ACCESSIBILITY ASSESSMENT REPORT

PROJECT:	Stage 1 - 400-404 Cabramatta Road West, 2-18 Orange Grove Road & 6 Links Avenue Cabramatta NSW 2166
STAGE:	Development Application Phase
REFERENCE:	22010A.4-ACCESS
DATE:	23 rd May 2023
CLIENT:	Tcon Constructions Pty Ltd

Figure 2.1 – Pedestrian entrance

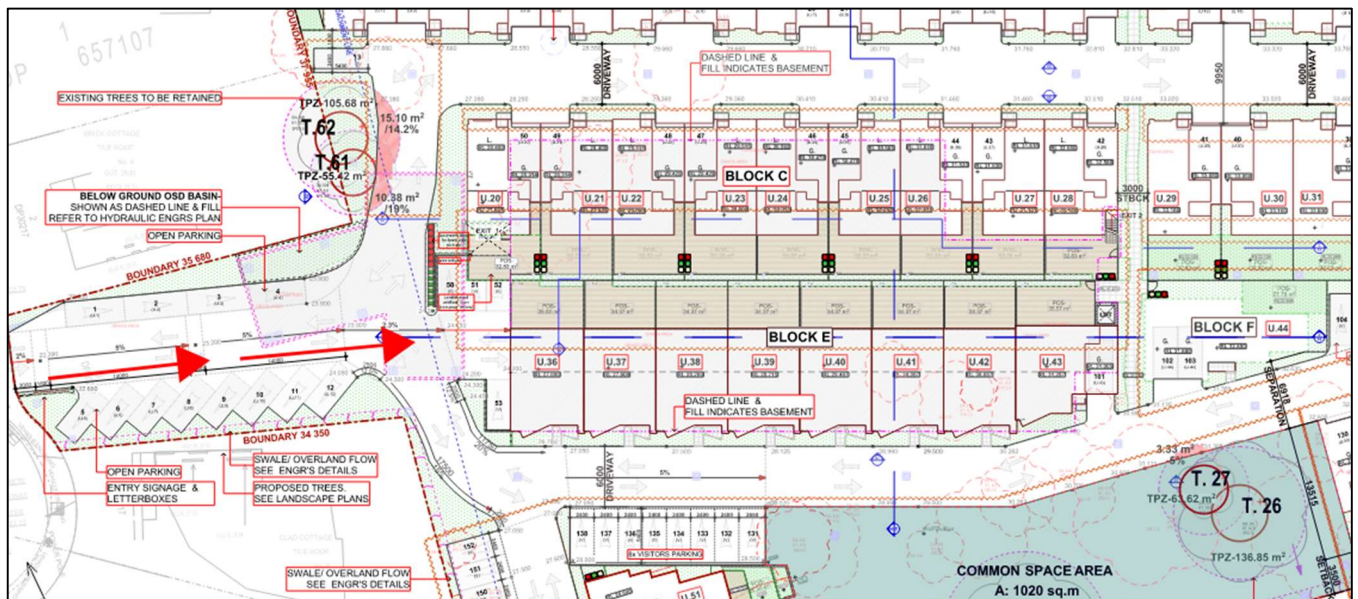
Referring to Figure 2.1 below, the principal pedestrian entrance to the building (highlighted red) from the road boundary (via Links Avenue) has been assessed as shown.

Figure 2.1 – Site Plan

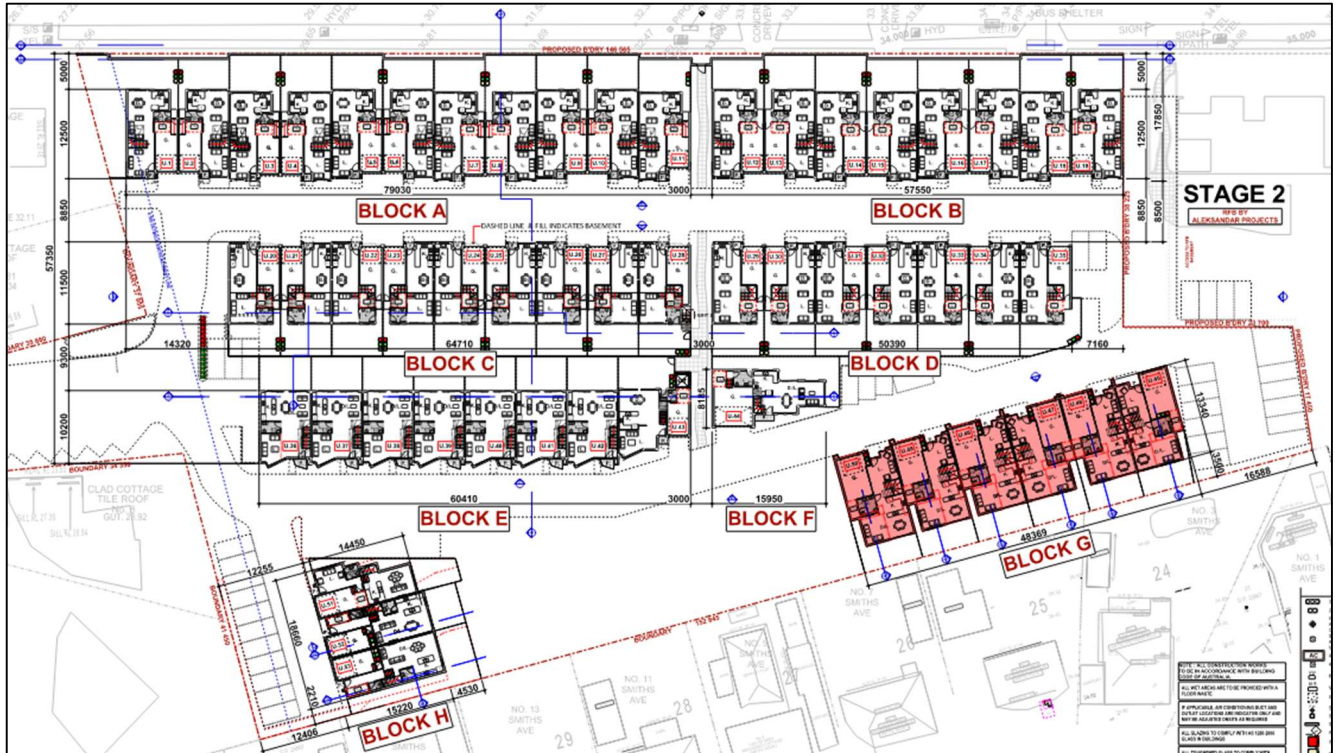
It is noted on plans assessed that 6 units, as highlighted **red** in the figures below, are proposed to be provided as adaptable.

Figure 4.1 – Outdoor common areas

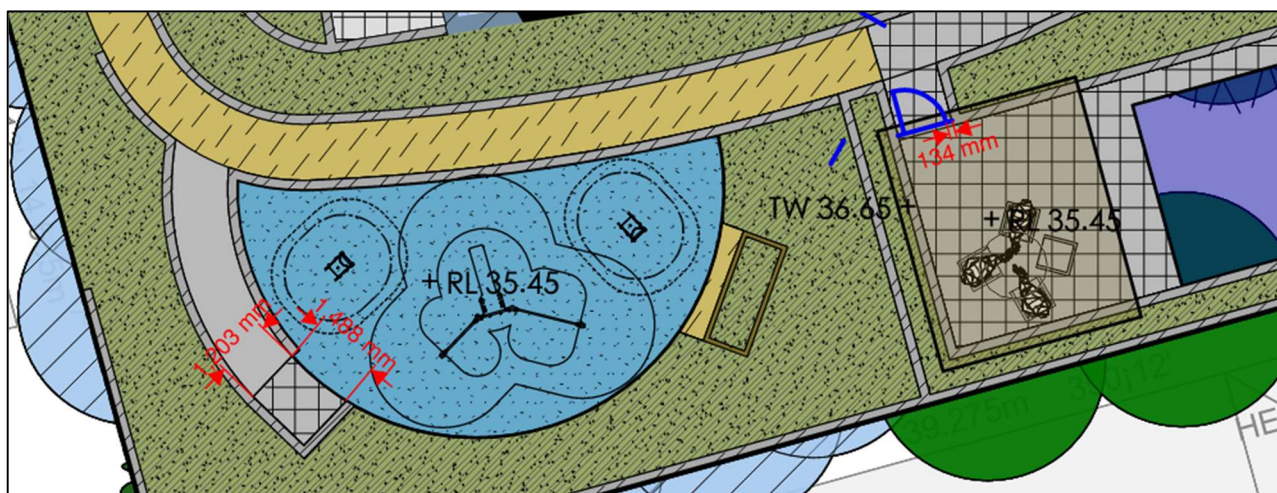
BCA Clause		Comment/s	Status
D3.1	General building access requirements	<p><u>Requirement/s</u></p> <p>Except as excluded under Section 2.7 of this report, access for people with a disability must be provided –</p> <ul style="list-style-type: none"> (i) From a pedestrian entrance required to be accessible to at least 1 floor containing sole occupancy units and to the entrance doorway of each sole occupancy unit located on that level. (ii) To and within not less than 1 of each type of room or space for use in common by the residents, including a cooking facility, sauna, gymnasium, swimming pool, common laundry, games room, individual shop, eating area, or the like. (iii) Where a ramp complying with AS1428.1-2009 or a passenger lift is installed – <ul style="list-style-type: none"> (a) To the entrance doorway of each sole occupancy unit; and (b) To and within rooms or spaces for use in common by the residents, located on the levels served by the lift or ramp. (iv) To and within any level containing accessible carparking spaces. <p><u>Issue/s</u></p> <p>The following issues are identified -</p> <ul style="list-style-type: none"> (i) The door serving the outdoor swimming pool on the ground floor is provided with a latch side clearance of less than 530mm; and (ii) The turning space at the landing providing access to the outdoor common area located adjacent to the outdoor pool area is less than 1,500mm x 1,500mm to allow for a 90 degree turn. 	DNC

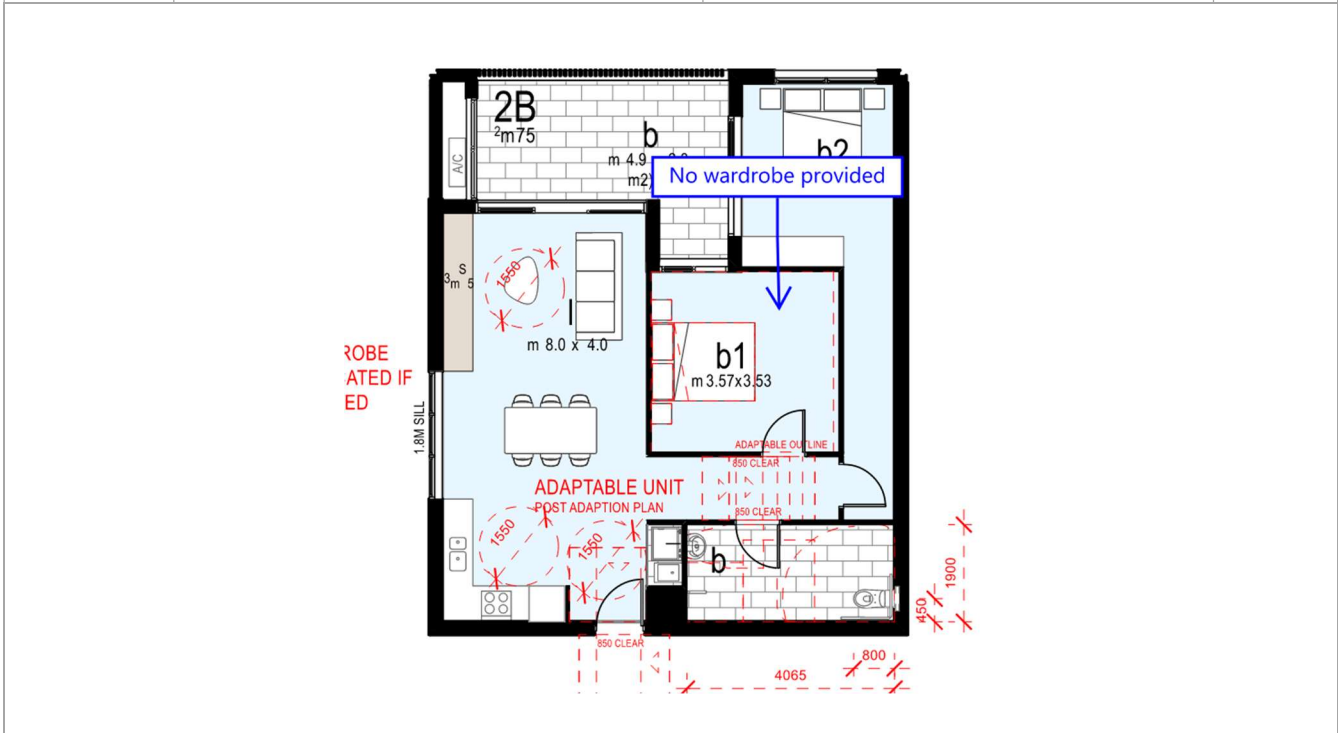
Clause No.	Requirement/s	Comment/s	Status
4.6.1	At least one bedroom shall be capable of accommodating a queen size bed and a wardrobe and the circulation space requirements of AS1428.2 clear of wardrobe fixtures.	<p>Details are to be provided to demonstrate that the main bedroom is provided with adequate clearances and circulation spaces, whilst being capable of accommodating a queen size bed (1530mm x 2030mm) and wardrobe –</p> <p>(a) 1m each side of the bed</p> <p>(b) A space of 1540mm x 2070mm at the foot of the bed</p>	DNC
